**PLEASANT PRAIRIE PLAN COMMISSION MEETING
VILLAGE HALL AUDITORIUM
9915 39th AVENUE
PLEASANT PRAIRIE, WISCONSIN
6:00 P.M.
July 23, 2018
AGENDA**

**PLEASANT PRAIRIE SPECIAL PLAN COMMISSION MEETING
VILLAGE HALL AUDITORIUM
9915 39TH AVENUE
PLEASANT PRAIRIE, WISCONSIN
5:30 P.M.
July 2, 2018**

**PLEASANT PRAIRIE PLAN COMMISSION MEETING
VILLAGE HALL AUDITORIUM
9915 39TH AVENUE
PLEASANT PRAIRIE, WISCONSIN
6:00 P.M.
July 9, 2018**

SHEET NUMBER:
C1.0

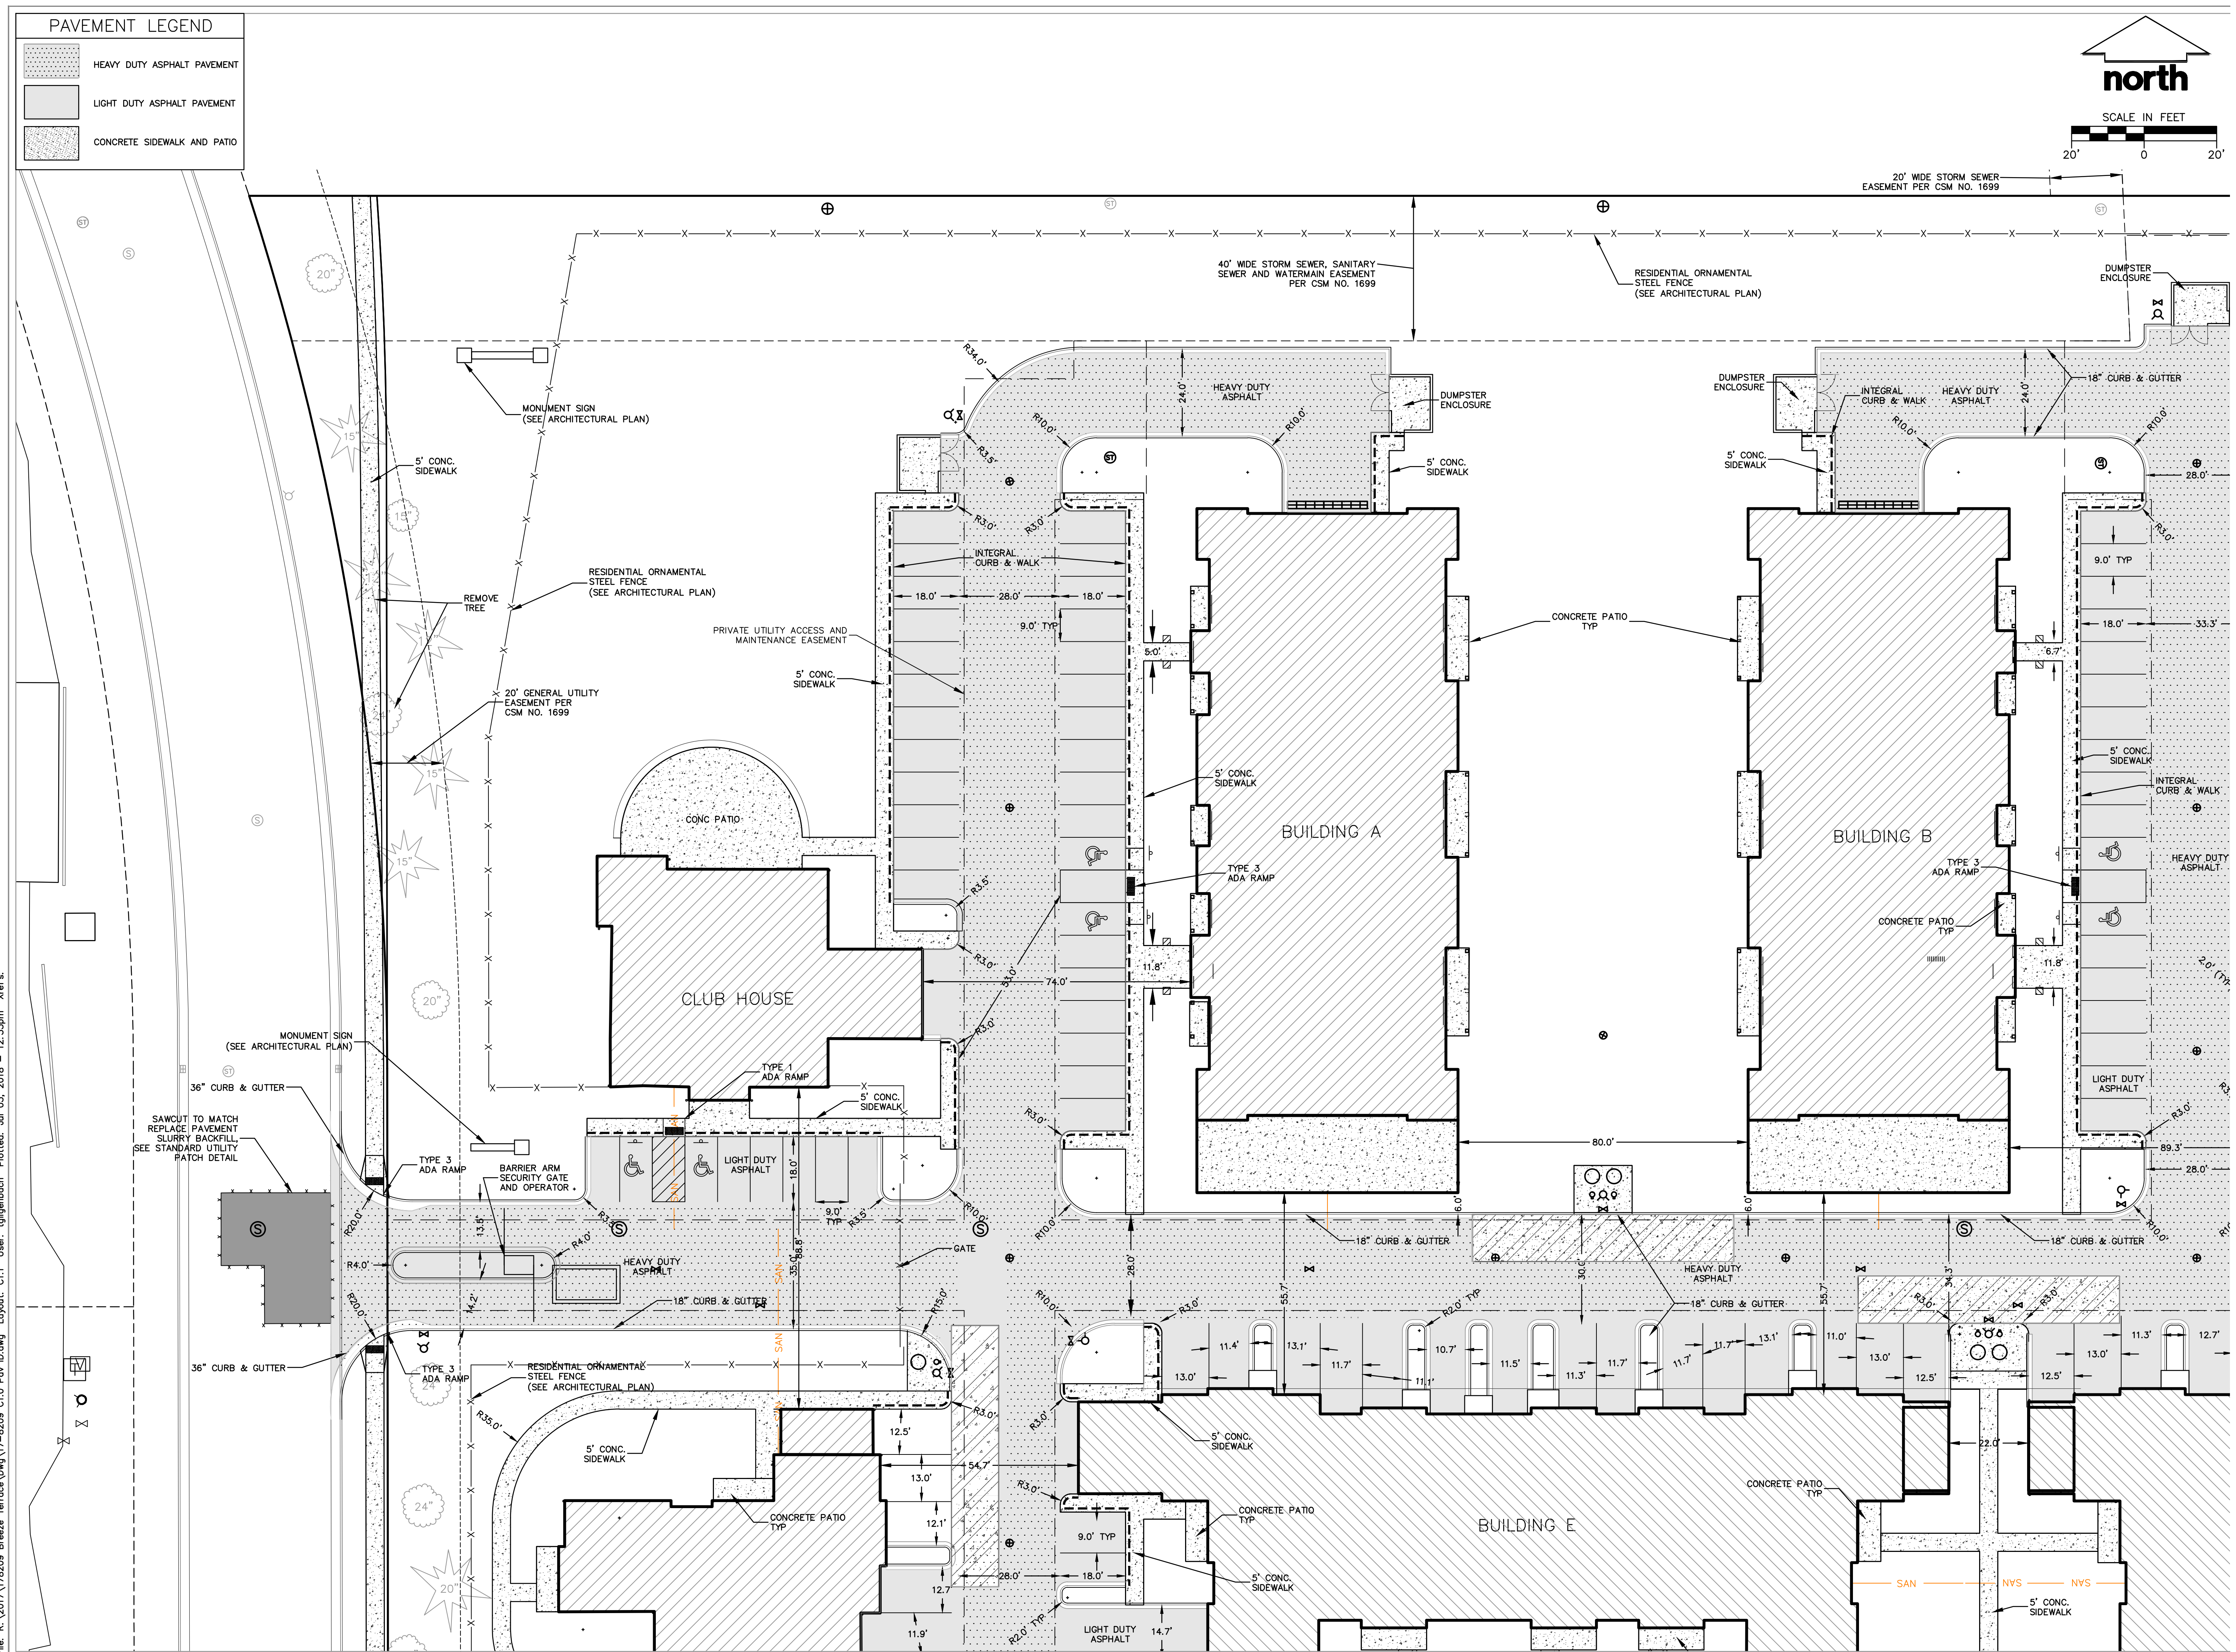
- e. On Sheet C1.0 label the 100-year floodplain. Provide the elevation and reference the FEMA Source for the elevation.
 - f. On Sheet C1.0 label and dimension all buildings, dumpsters, and paved surfaces (from back of curb) to the property lines. In addition, show the separate distance between buildings and the setback distance of the entry sign to the property line.

- g. On Sheet C1.0 show and label the no shooting deed restriction area on the adjacent property. Also show the distance between the eastern most building and the outer edge of the no shooting area to verify the minimum 300 foot separation distance is being met.

- i. Provide a site data chart on the sheet C1-0 that includes the following:
 - i. Total lot area (without street vacation area)
 - ii. Total lot area (with street vacation)

- j. Sheets C1-0 and SP1.1a shall be identical—update Sheet SP1.1a to reflect all changes required to sheet C1-0.
- k. The parking count on Sheet SP1.1a does not match the parking count on Sheet G001. Revised the sheets so that they are consistent.

- m. Sheets C1-0 indicates that the Monument Sign details are shown on the architectural plans-details are not shown on the architectural plans. Also only one (1) Sign is allowed for the development. This sign should be located at the main entrance. Revised the plans.
